CERTIFICATE OF APPROPRIATENESS

RE: Application Number 21-7222; 1920 Atkinson, Atkinson Avenue Historic District

THE RECTORY

04 - 12 - 2021 HDC Set

1 North Elevation - Pergola
A2.0 1/4" = 1'-0"

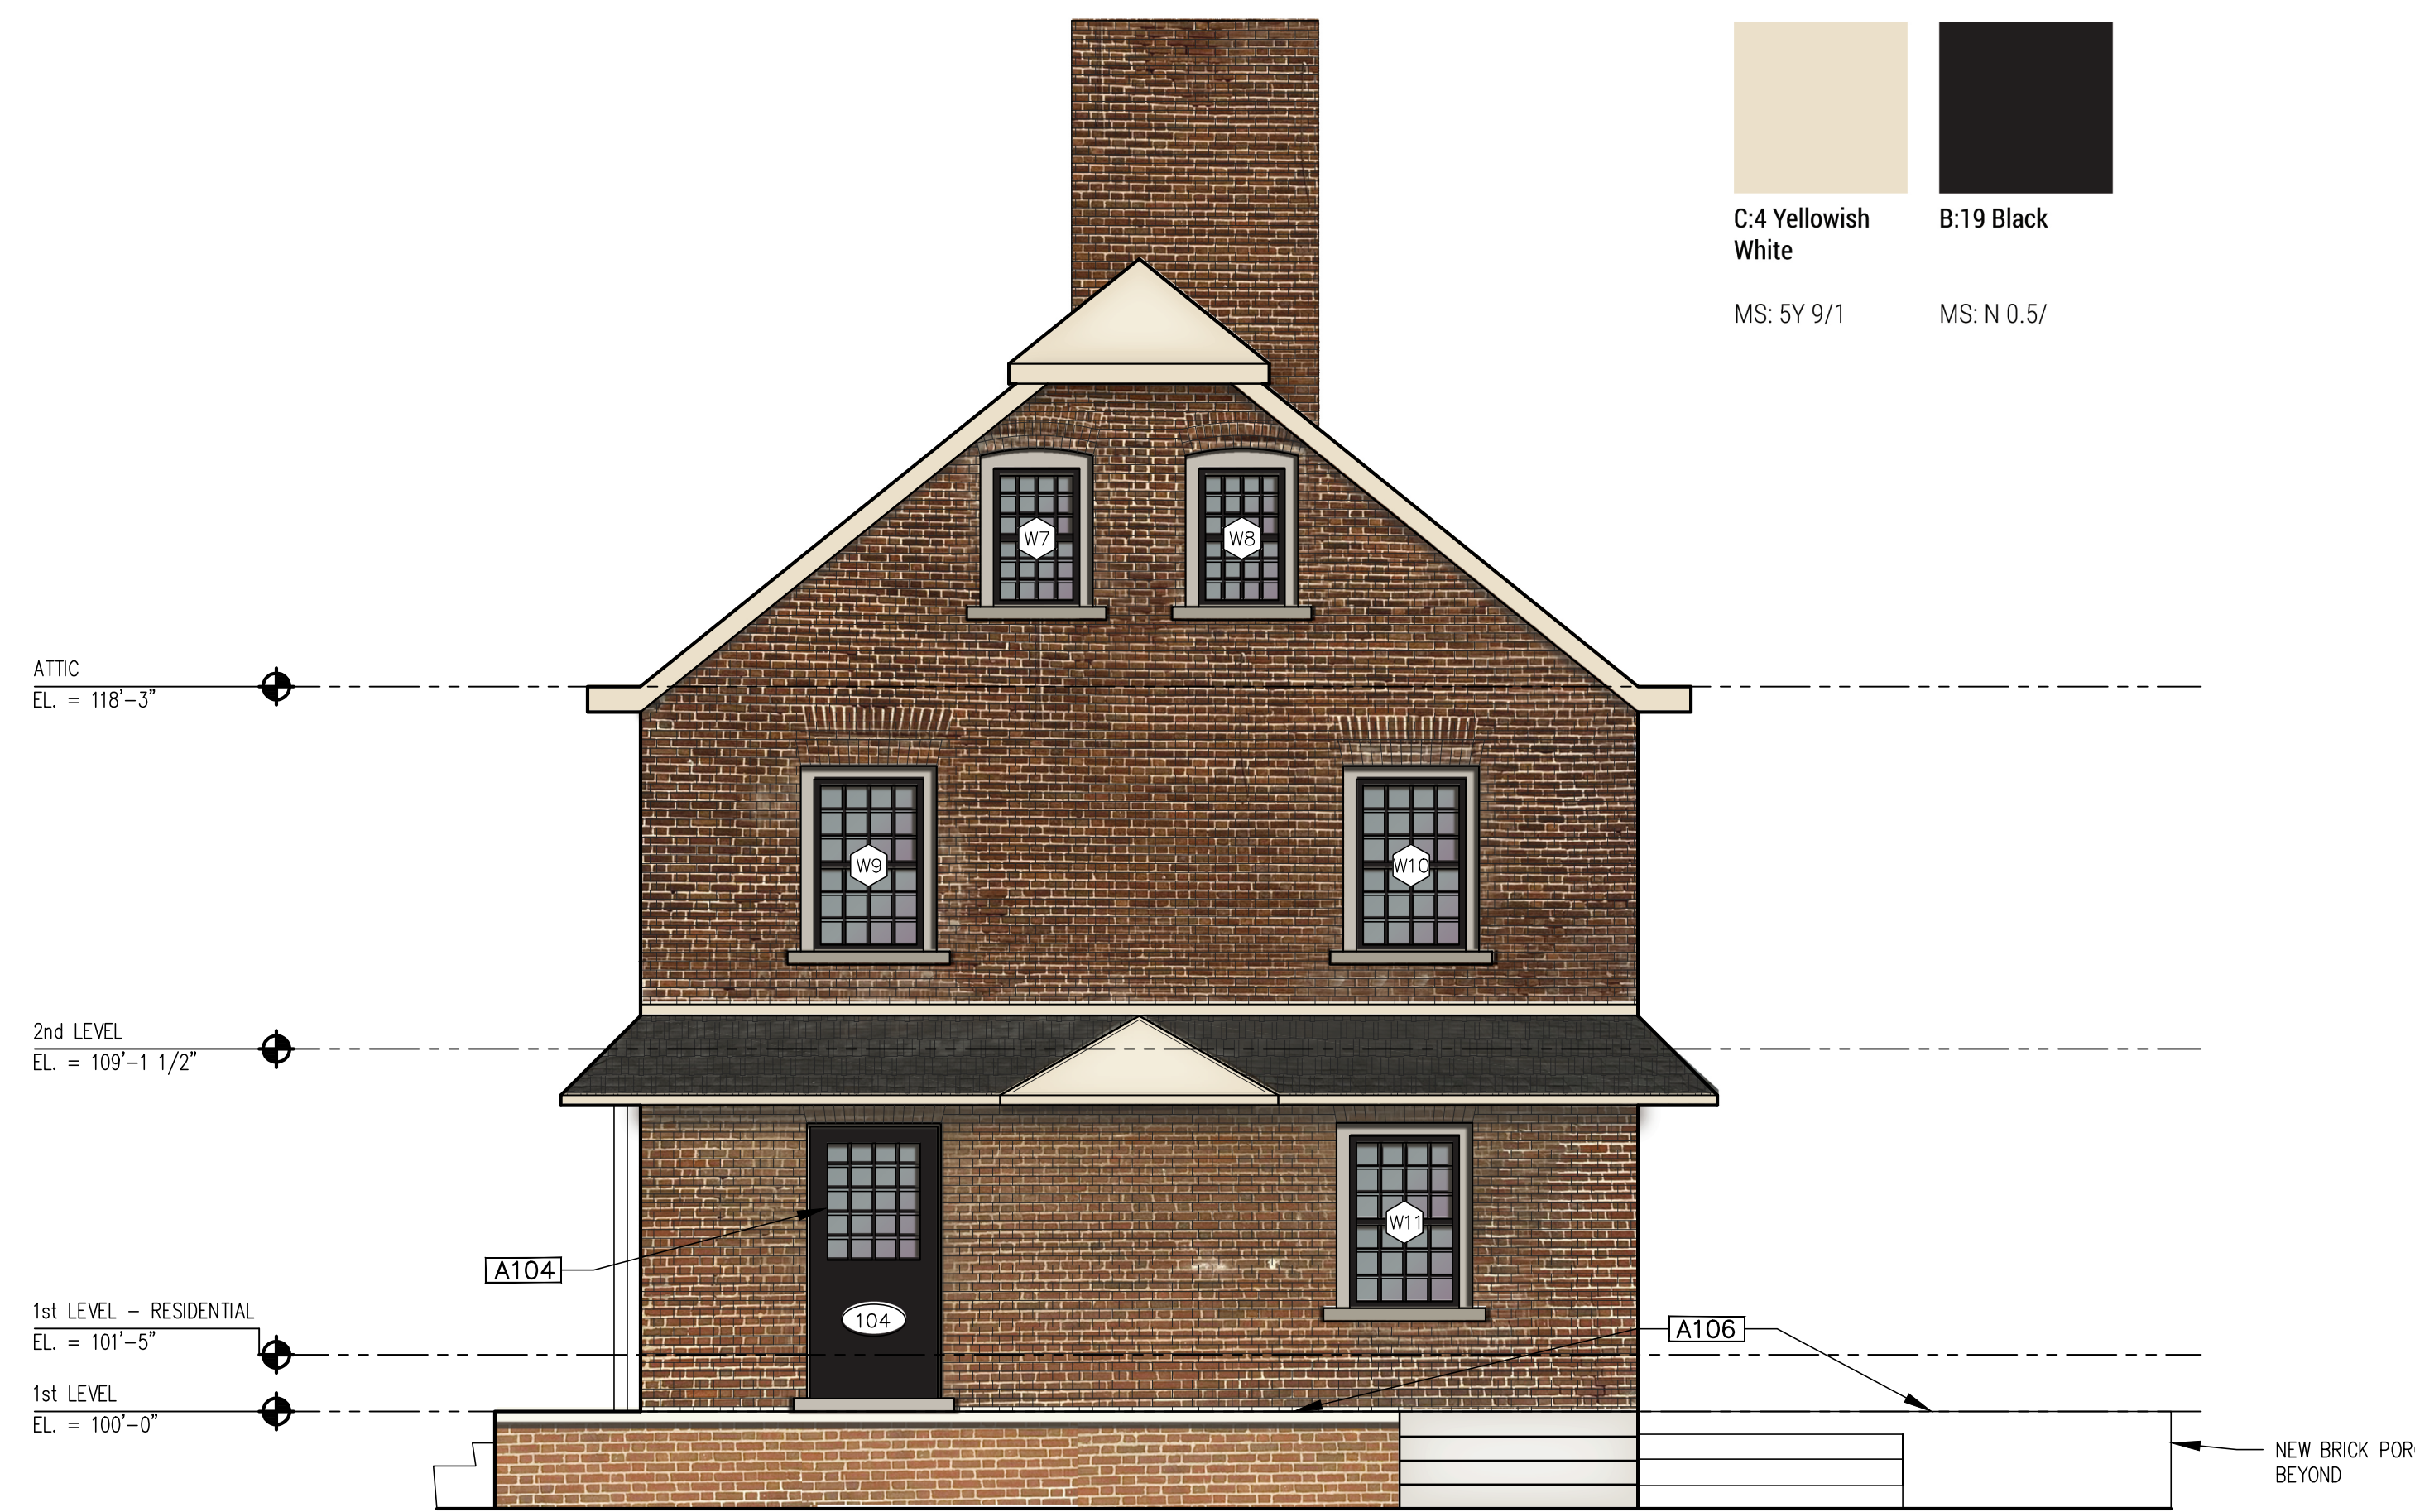
- 02: Elimination of an Existing Window (DW) for New Residential Door Entrance (103) at the back of the building.
 - New door sill height.
- 03: Move the Door (103) higher and further west to accommodate the new Residential Door Entrance (103) at the back of the building.

- A catalog cut for the rear entry railing will be submitted for staff review.
- Evidence of the window and door opening proposed for removal on the rear elevation will be retained and will consist of: the double rowlock headers and the brick infill will be laid in a running bond pattern within the openings. Vertical joints will be used to separate the infill brick from the existing brick wall.

NORTH ELEVATION

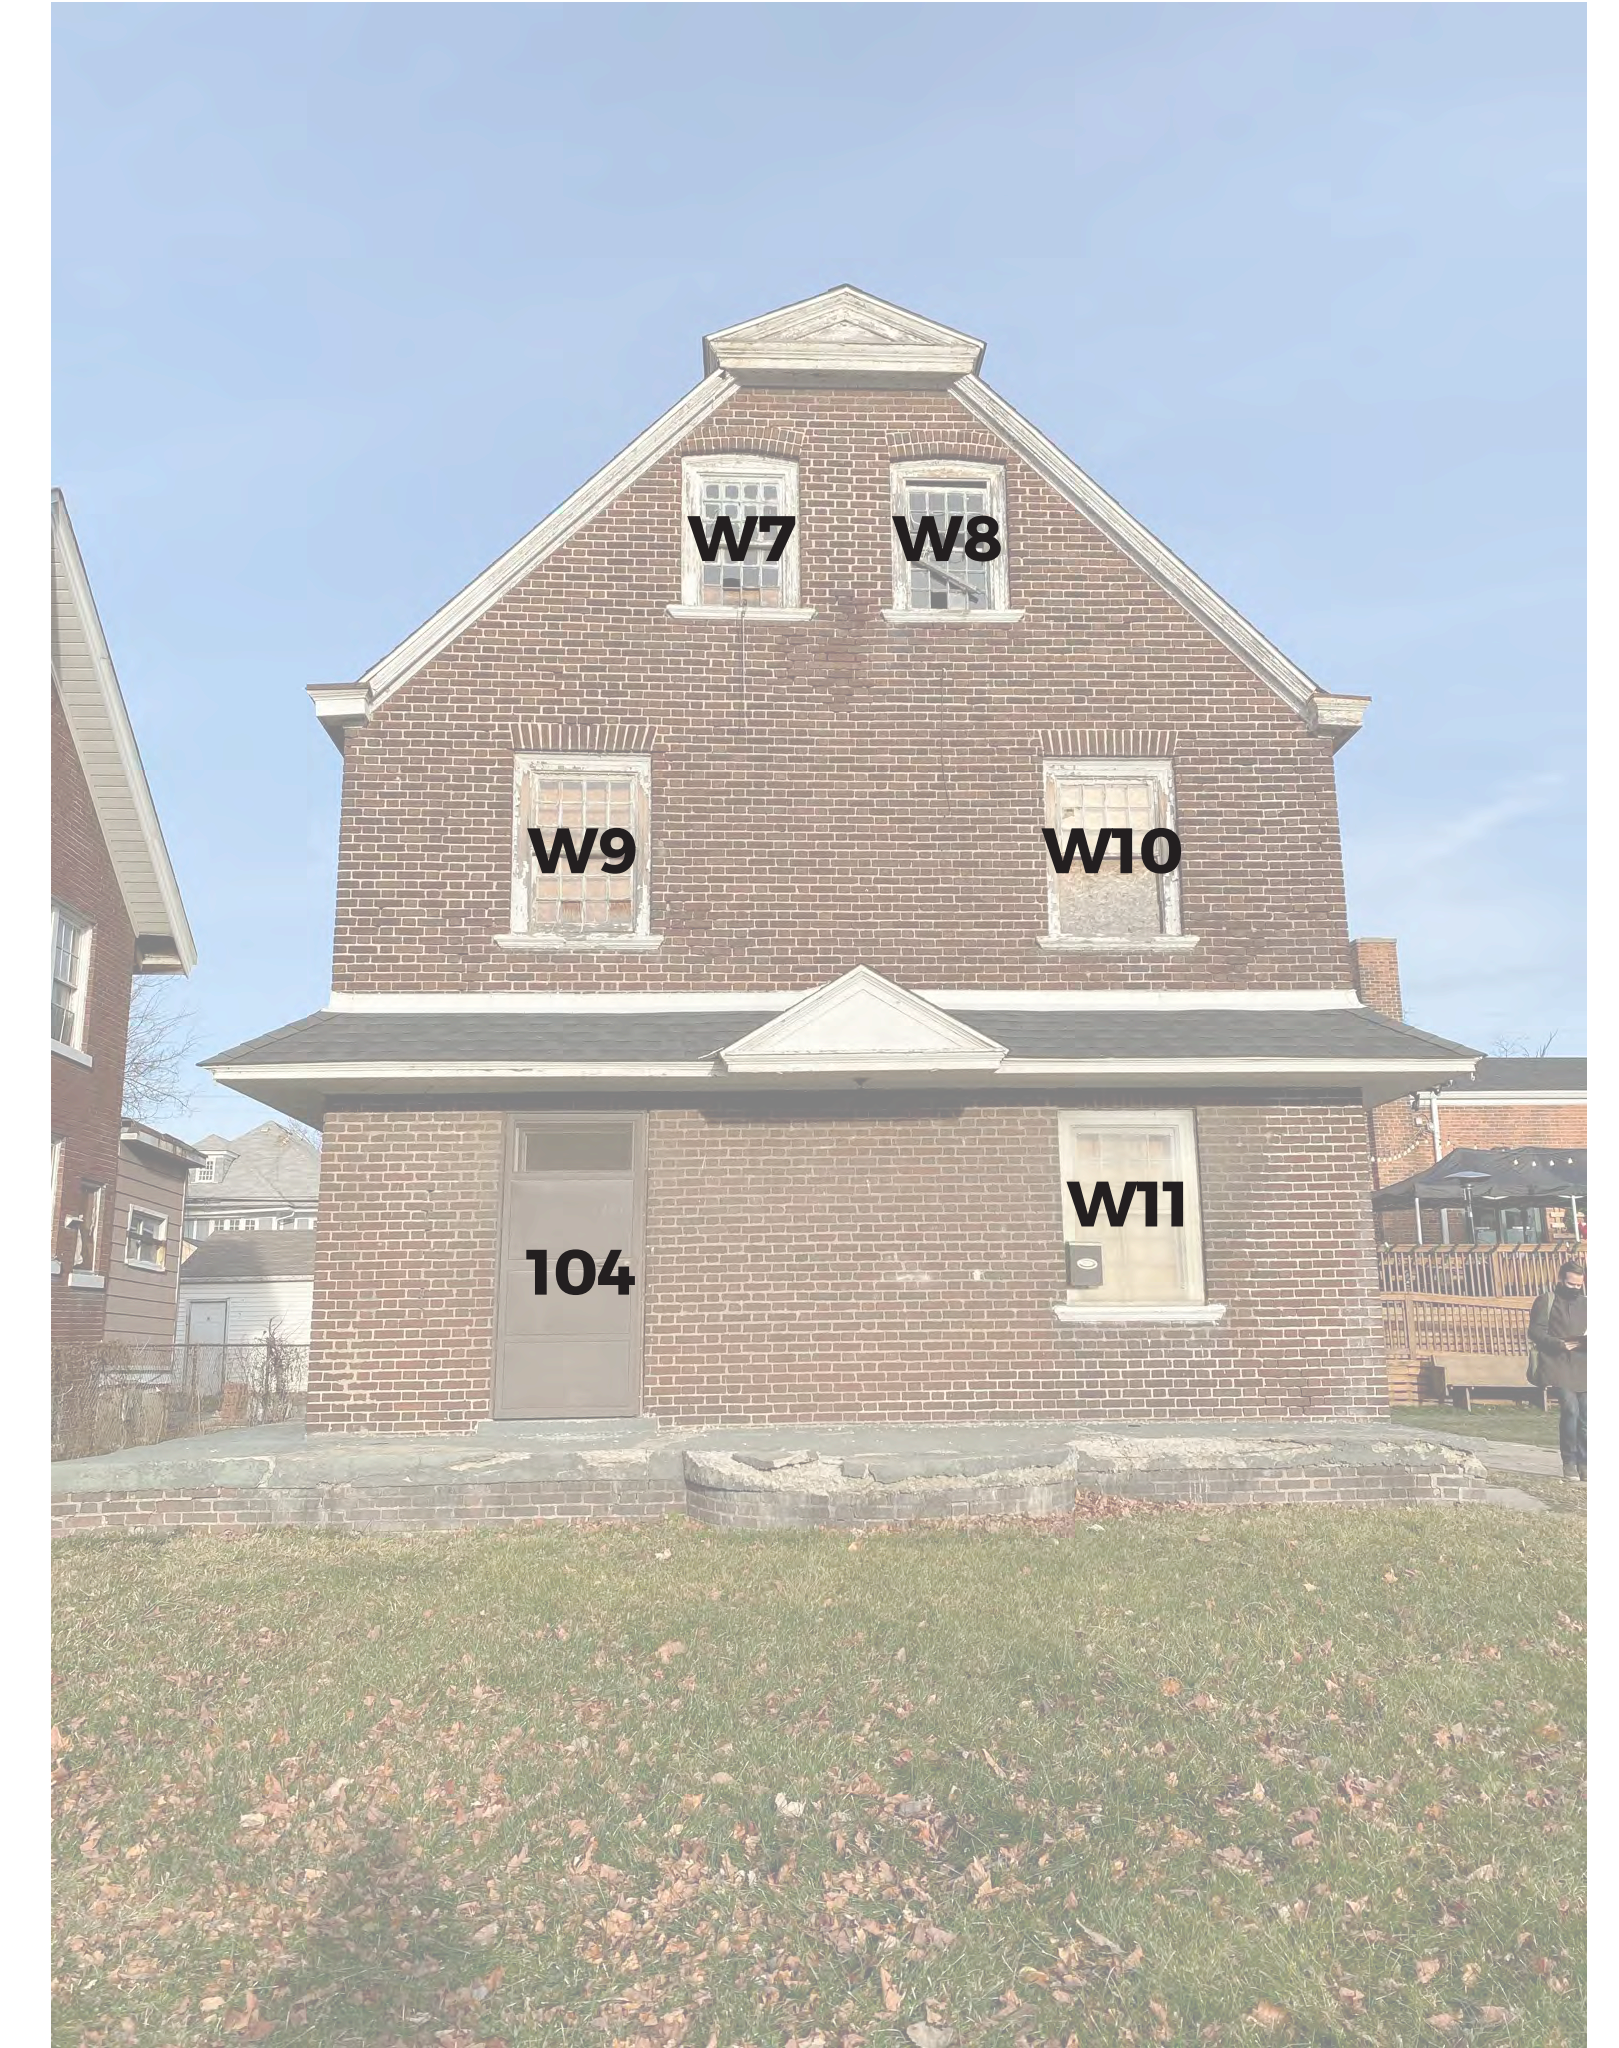
REMOVING WINDOW TO
MOVE DOOR 103 UP FOR
NEW PATIO - SEE
ELEVATIONS AND PLANS
